# SERVICE BULLETIN

M-1236

Safety Recall Code 0136

## 2009 Dyna Fuel Tank Vent Tube Assembly Recall

Figure 1. Vent Tube Connections

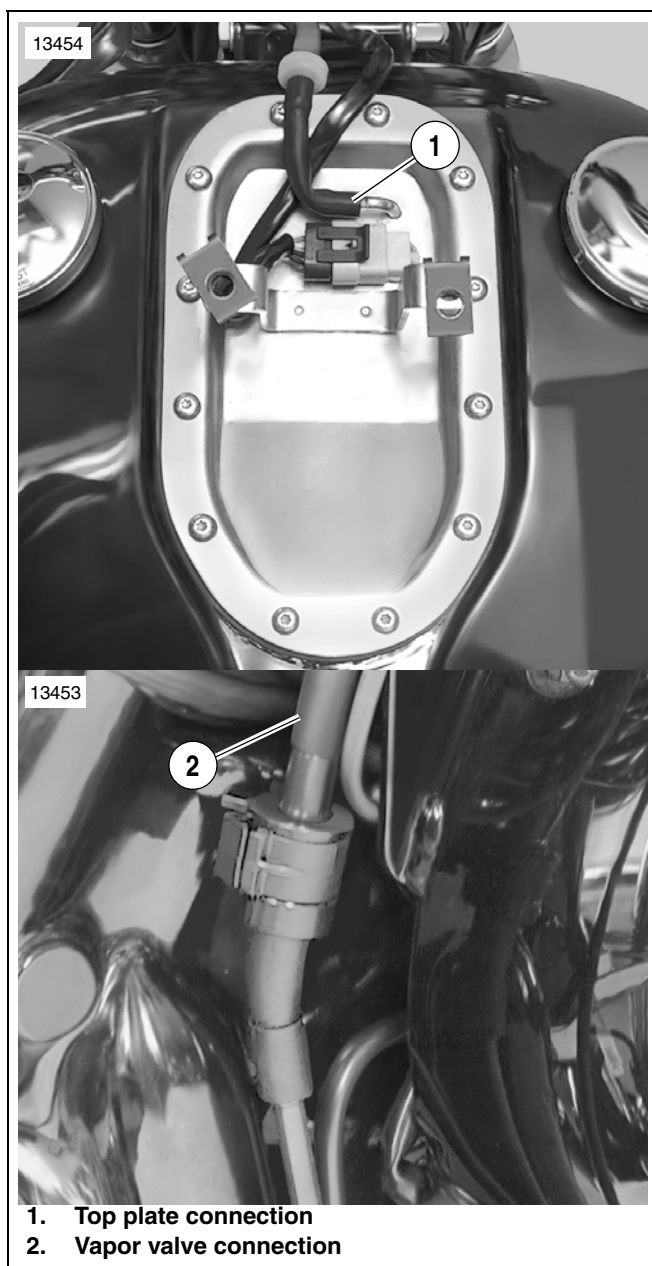
See Figure 1. Do not remove vent tube at slosh valve. Remove vent tube at top plate (1) and vapor valve (2).

Figure 2. Anti-slosh Valve

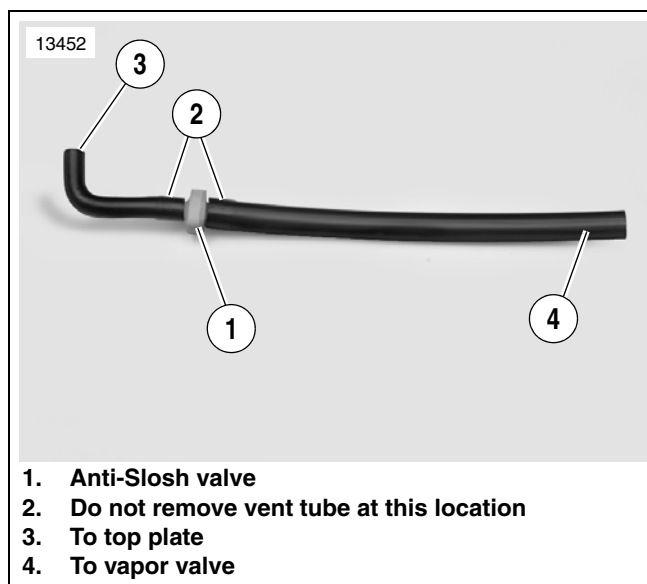
4. Remove the anti-slosh valve and attached vent tubes.
5. See Figure 2. Install **new** anti-slosh valve and vent tubes from the recall kit.
6. Install instrument panel. See Chapter 7 of the 2009 DYNA Models Service Manual.
